This gallery shows some pictures of bad solderings - they should prevent you from making the same errors (feel free to add even more pictures here!)

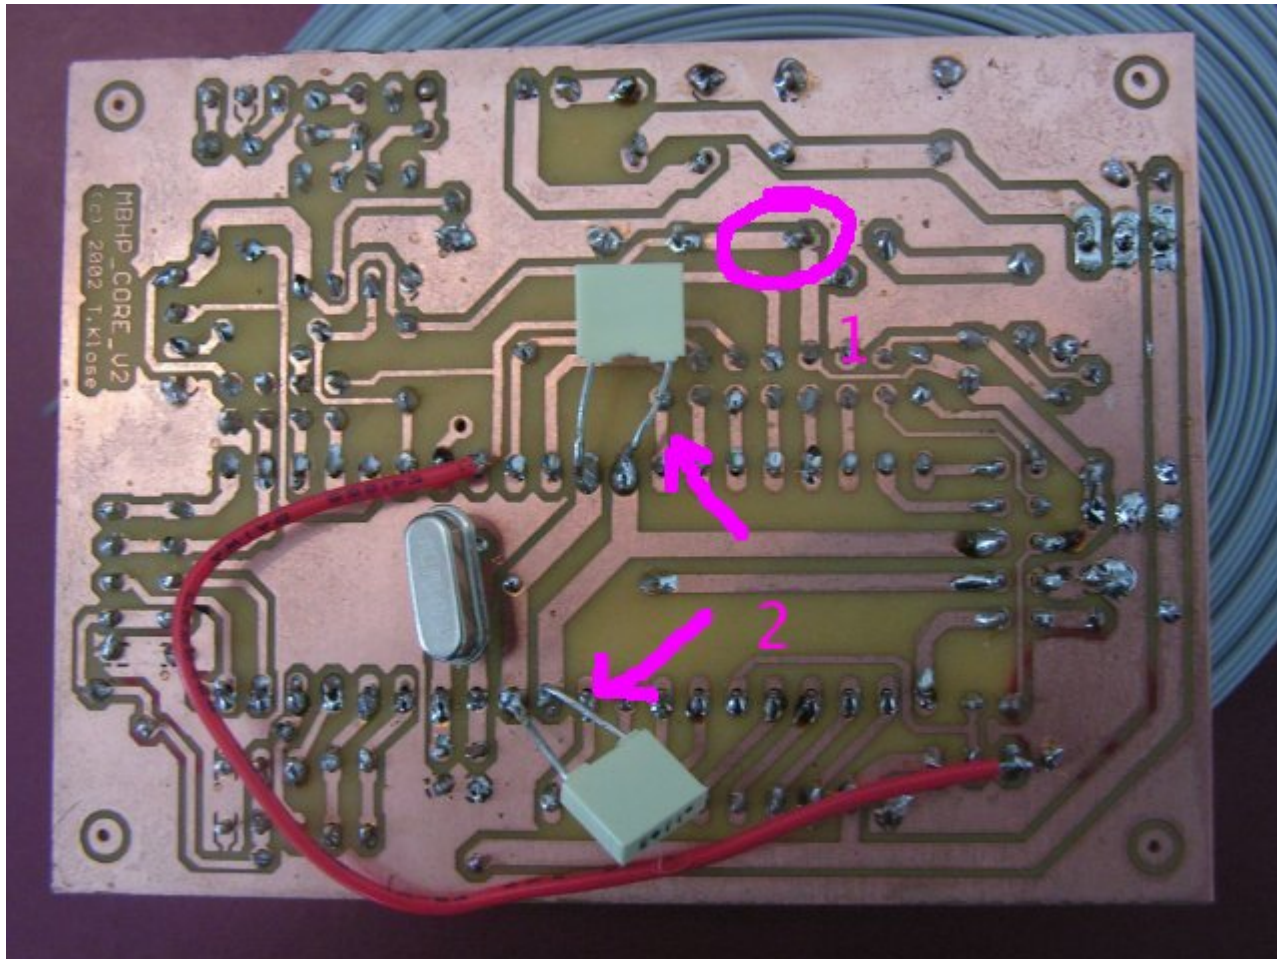
1: The core module has some badly soldered connections(loose), which could lead to failures. There are also missing solderings (e.g. 33pF cap below crystal). It makes sense to solder each pad again, the [Soldering](#) guide in the Wiki gives some useful tips

2: The legs of the caps should be cut, otherwise they can cause a short circuit which can damage the PIC!

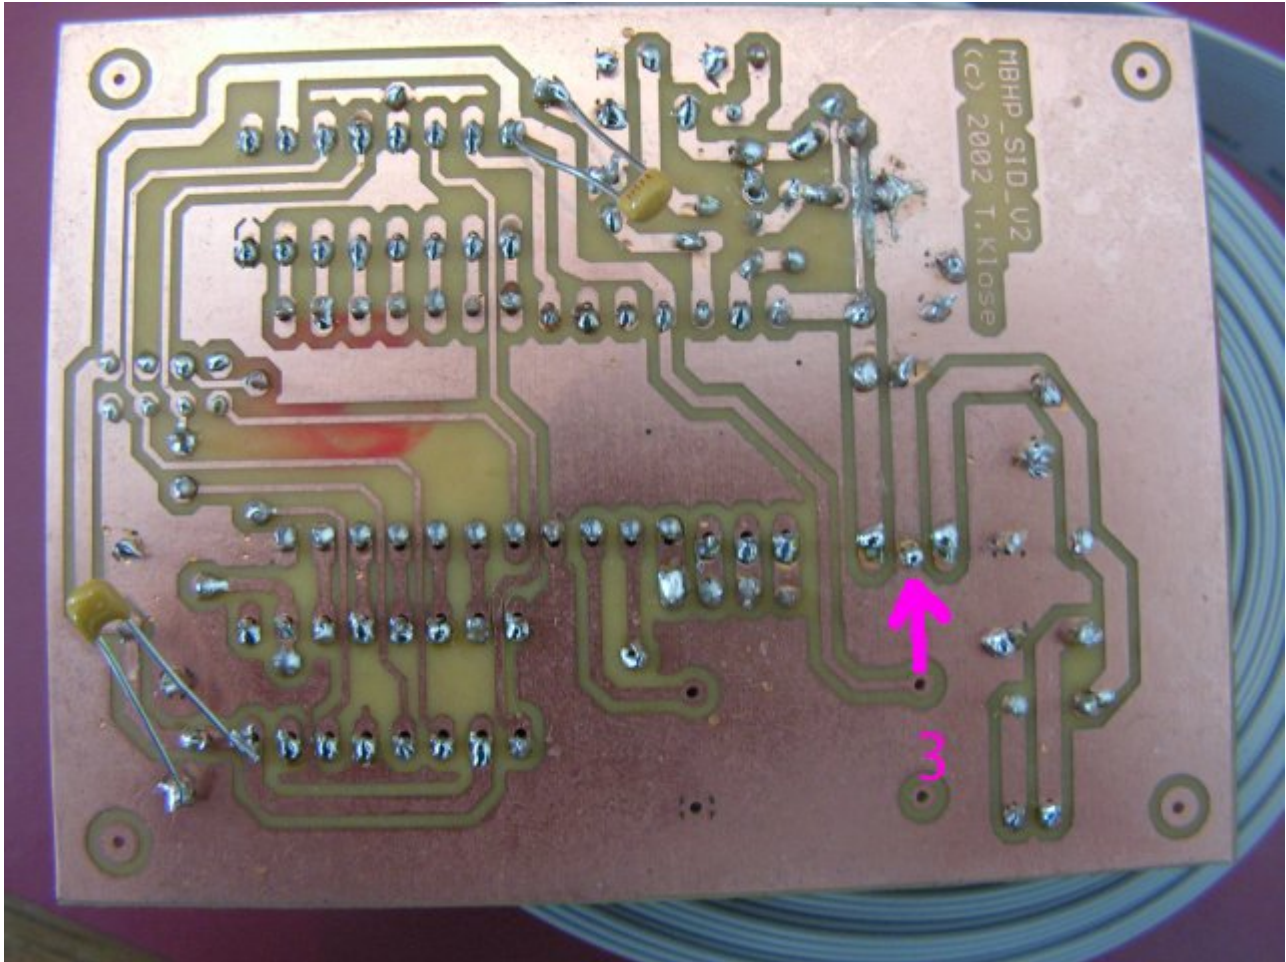
3: This seems to be a bad ground connection directly at the 78xx - it can lead to the wrong voltage. Here the same: just solder the pads again, it will help  
And same as above: the long cap legs need to be cut, the danger of shorting out is too high!
